**From:** [Ritzen, Brenda](#)  
**To:** [Thalia Rivas](#); [Olvera, Brandon](#)  
**Subject:** RE: Revisions: Permit 117239 Address: 2514 Cypress Gardens  
**Date:** Wednesday, May 1, 2024 4:04:00 PM  
**Attachments:** [image001.png](#)

### **Permit of Authorization to Construct an On-Site Sewage Facility Permit Valid For One Year From Date Issued**

Permit Number: 117239  
Issued This Date: 03/15/2024  
This permit is hereby given to: Zerep Enterprises LLC

# Drip Tubing System

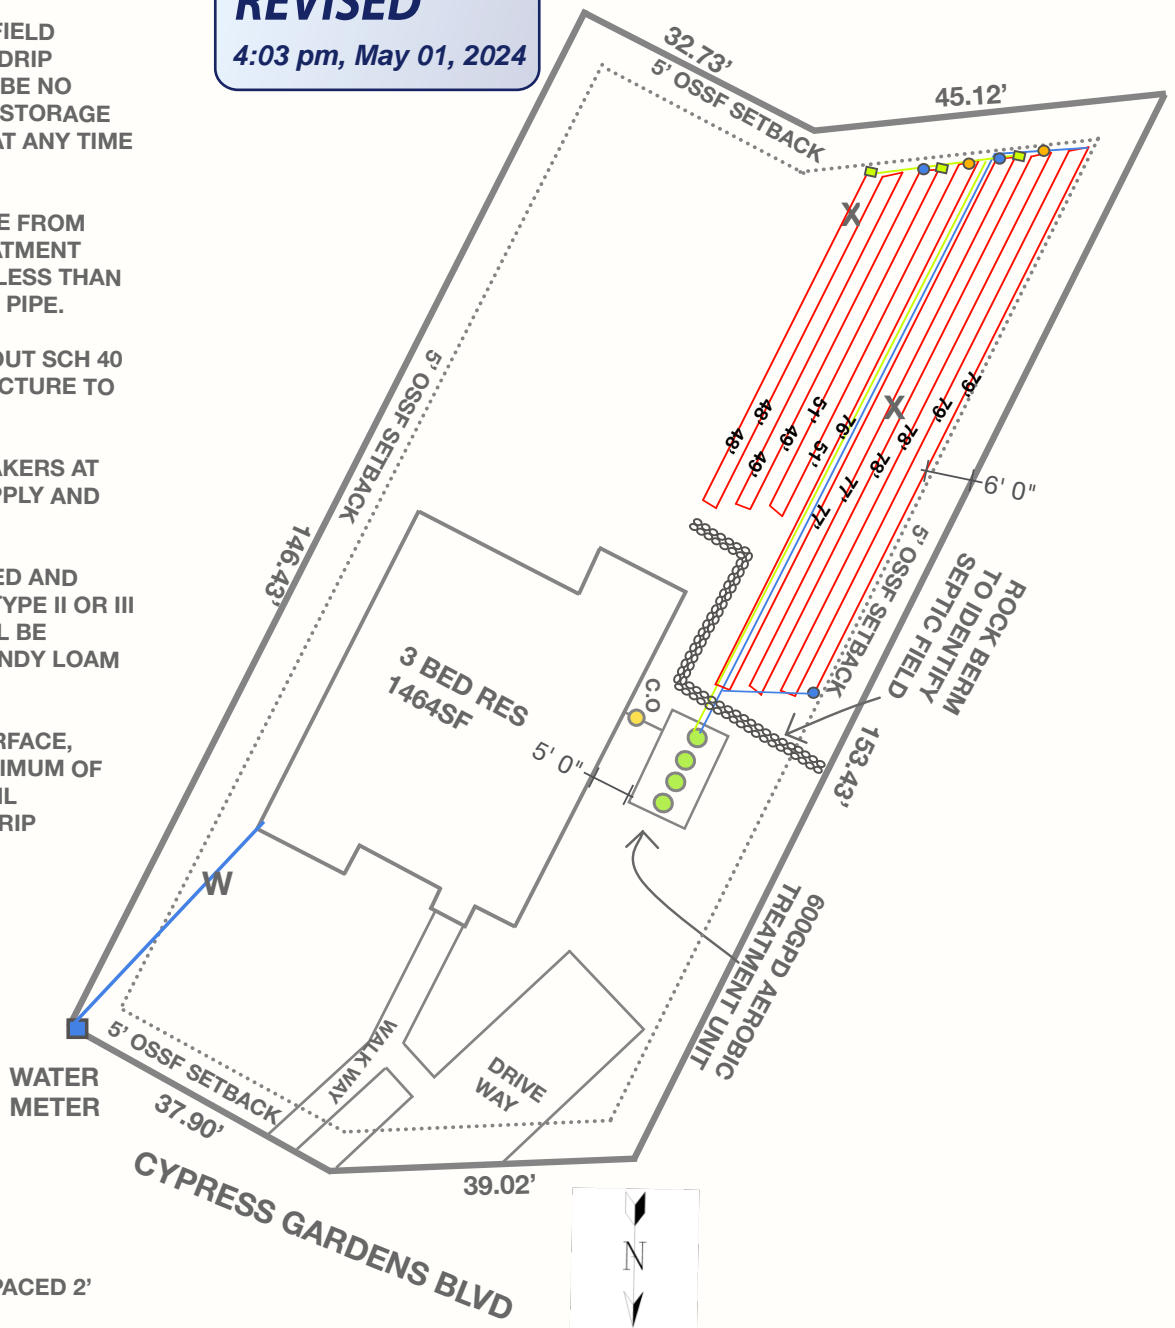
Will the rock berm have any impact on the sewer line running underneath it?

INSTALL 1680SQFT OF FIELD TUBING USING 840' OF DRIP TUBING. THERE SHALL BE NO PARKING, DRIVING, OR STORAGE ON THE SEPTIC FIELD AT ANY TIME FOR ANY REASON.

2 LINES @ 79' EACH  
2 LINES @ 78' EACH  
2 LINES @ 77' EACH  
1 LINES @ 76' EACH  
2 LINES @ 51' EACH  
2 LINES @ 49' EACH  
2 LINES @ 48' EACH

840' OF DRIP TUBING SPACED 2' APART.

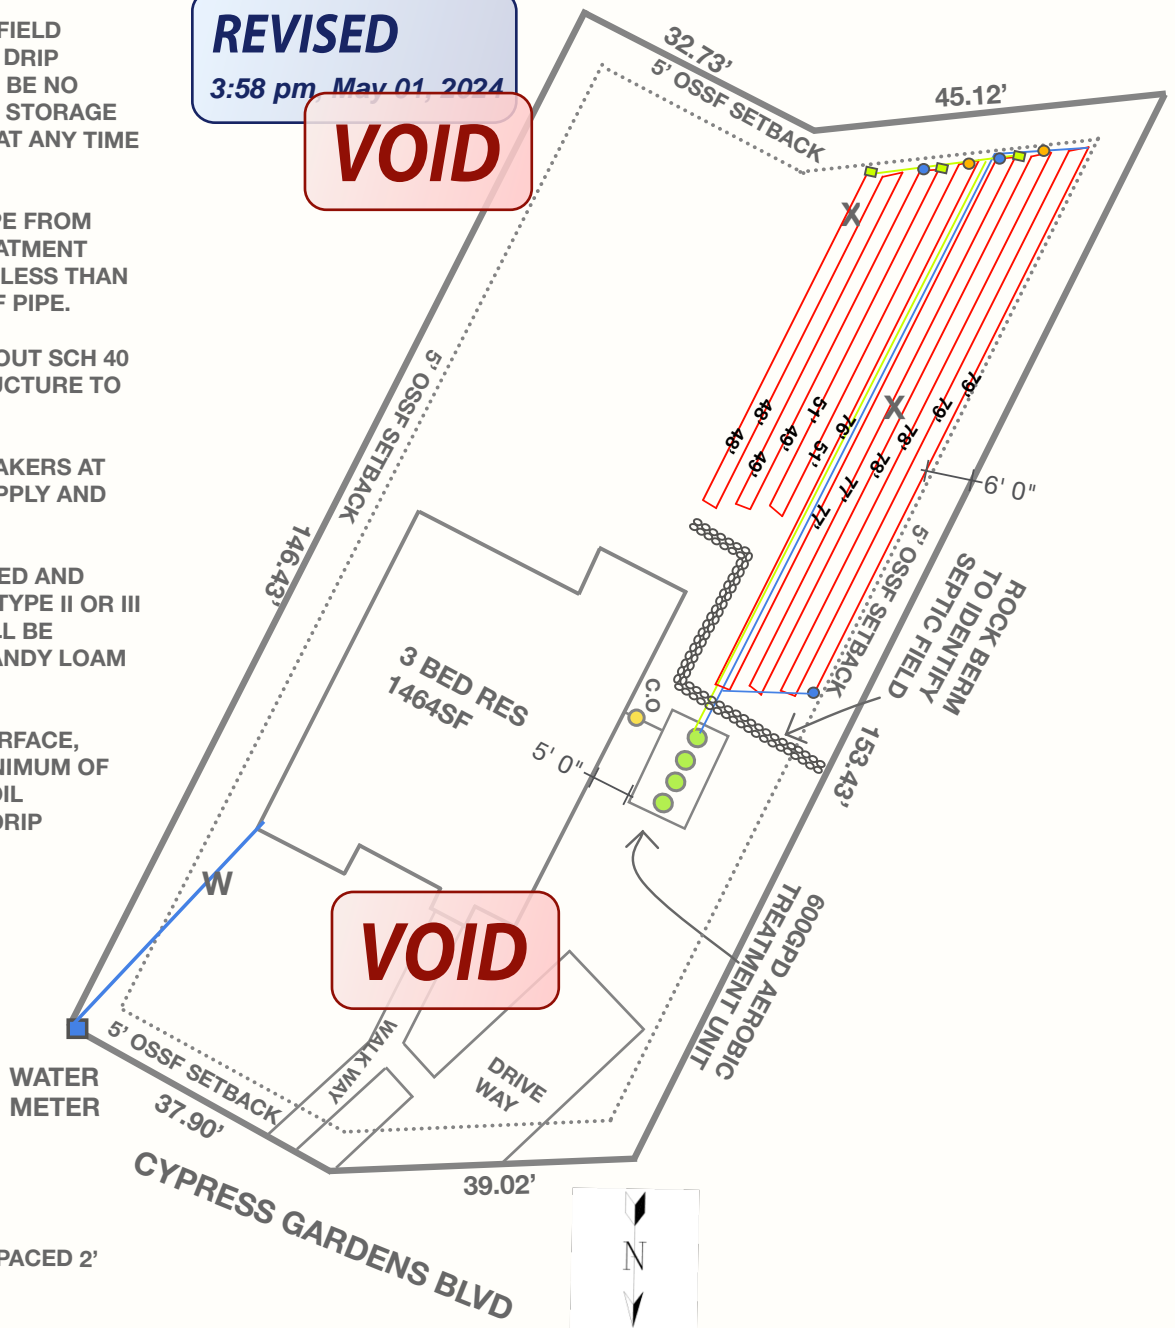
Will the rock berm have any impact on the septic line running underneath it?

INSTALL 1632SQFT OF FIELD TUBING USING 816' OF DRIP TUBING. THERE SHALL BE NO PARKING, DRIVING, OR STORAGE ON THE SEPTIC FIELD AT ANY TIME FOR ANY REASON.

INSTALL:  
2 LINES @ 79' EACH  
2 LINES @ 77' EACH  
2 LINES @ 76' EACH  
2 LINES @ 75' EACH  
2 LINES @ 51' EACH  
2 LINES @ 50' EACH

816' OF DRIP TUBING SPACED 2' APART.
